UNITED STATES PATENT AND TRADEMARK OFFICE

APPLICATION NO.	FILING DATE	FIRST NAMED INVENTOR	ATTORNEY DOCKET NO.	CONFIRMATION NO.
10/803,242	03/18/2004	Hans-Jurgen Muller	P04,0038	5979
26574	7590	04/26/2007	EXAMINER	
SCHIFF HARDIN, LLP PATENT DEPARTMENT 6600 SEARS TOWER CHICAGO, IL 60606-6473			KIKNADZE, IRAKLI	
			ART UNIT	PAPER NUMBER
			2882	
SHORTENED STATUTORY PERIOD OF RESPONSE		MAIL DATE	DELIVERY MODE	
3 MONTHS		04/26/2007	PAPER

Office Action Summary	Application No. 10/803,242	Applicant(s) MULLER, HANS-JURGEN	
	Examiner Irakli Kiknadze	Art Unit 2882

FIG. 6

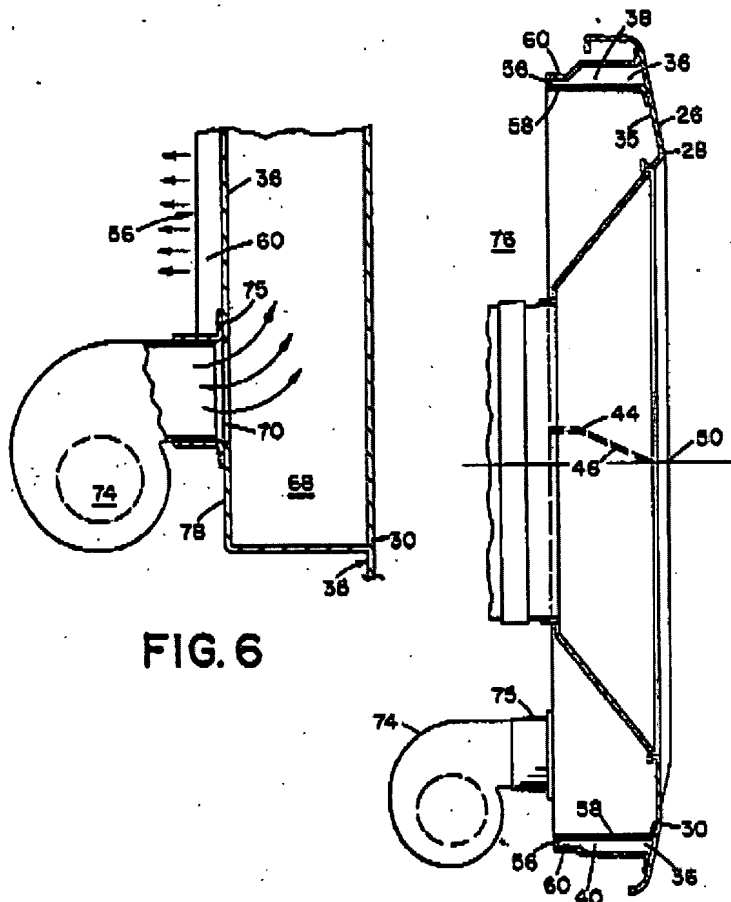
With respect to claims 1, 17 and 18, Zupancic teaches a cooling method and system for components such as the x-ray detectors (20) and other features of a computer tomography system arranged in a gantry housing (Figs. 1-3 and 6; see abstract; column 2, lines 10-14), comprising:

an air compressor (74) operable to compress air (Figs. 2, 3 and 6; column 4, lines 48-50 and 54-60; and

cooling duct (36) see column 4, lines 7-12 and a nozzle opening (56) see column 4, lines 54-60) connected to receive and dispose air flows directly onto the components (20) to be cooled (column 4, lines 7-12, 22-23, 54-60 and 64-68).

With respect to claim 2, Zupancic teaches that the air compressor (74) positioned adjacent to the elements to be cooled. The air compressor (74) is operable to accept and compress ambient air (Fig. 2, 3 and 6; column 4, lines 48-50).

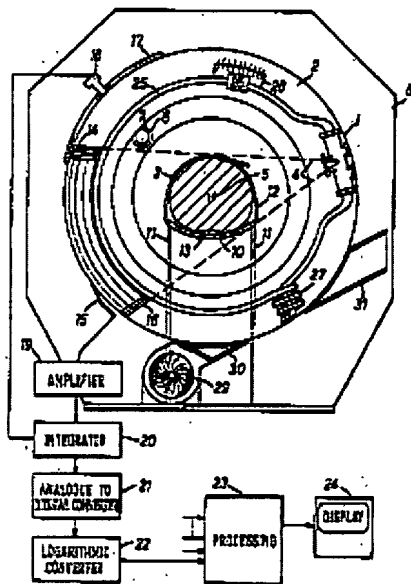
With respect to claims 12-14 and 20, Zupancic teaches claimed invention except for openings through which heated air escapes outwards or an exhaust device operable to draw heated air from the gantry housing. Hounsfield teaches a cooling method and system for components of a computer tomography system arranged in a gantry

housing (8), comprising: flow-through openings (31),

which may be fan assisted, through which a heated air escapes from the gantry housing (8) (see Fig; column 3, lines 30-33) to improve cooling efficiency of the components arranged in the gantry.

FIG.19

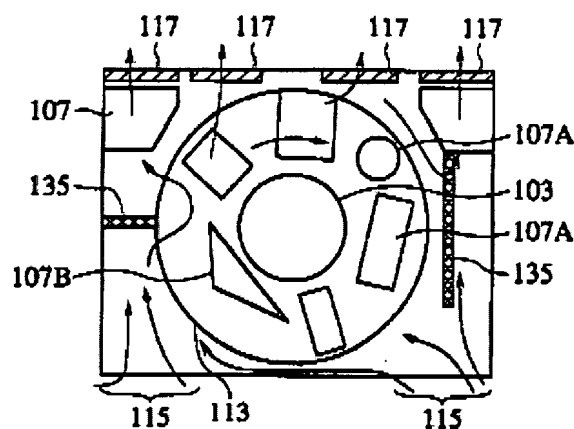
With respect to claims 12-14 and 20, Zupancic teaches claimed invention except for openings through which heated air escapes outwards or an exhaust device operable to draw heated air from the gantry housing. Sugihara teaches a cooling method and system for components of a computer tomography system arranged in a gantry

housing, comprising: flow-through openings

through which a heated air escapes from the gantry housing, wherein the heated air is discharged by a fan (117) (see Fig 19; column 7, lines 33-36) to improve cooling efficiency of the components arranged in the gantry (column 2, lines 31-35).
